**BEFORE THE BOARD OF PATENT APPEALS
AND INTERFERENCES**

Application Number: 10/531,622
Filing Date: April 14, 2005
Appellant(s): FOELL ET AL.

EXAMINER'S ANSWER

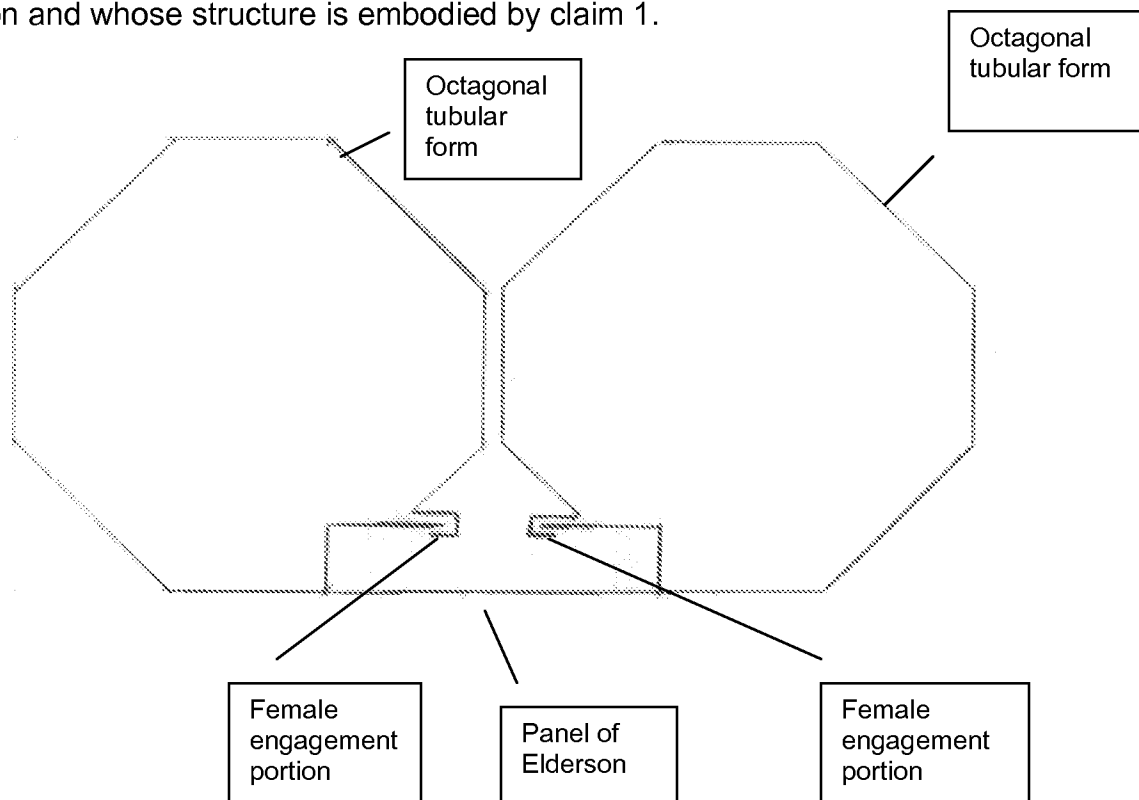
structure is capable of performing the intended use, then it meets the claim. In this case, each male engagement portion 20 of Elderson including each fin, (e.g., all of 20 or the respective section extending outwardly from portion 20, [i.e., the foot portion of the L-shaped flange 20 thereof]), can “engage a matching female engagement portion”. Thus, Elderson as along 20 can engage respective matching female engagement portions of any two elongated octagonal form elements. Claims 1, 6 and 8 appear directed to nothing more than a panel. No particular octagonal form elements are positively claimed thus, no particular form assembly is positively defined within claims 1, 6 and 8.

In any event, one can see from the examiner’s rendition illustrated below that the “panel” of Elderson can indeed be used with and engage respective matching female engagement portions of any two elongated octagonal form elements. See also, appellant’s embodiment of Figure 35 which has the same structural characteristics as Elderson and whose structure is embodied by claim 1.
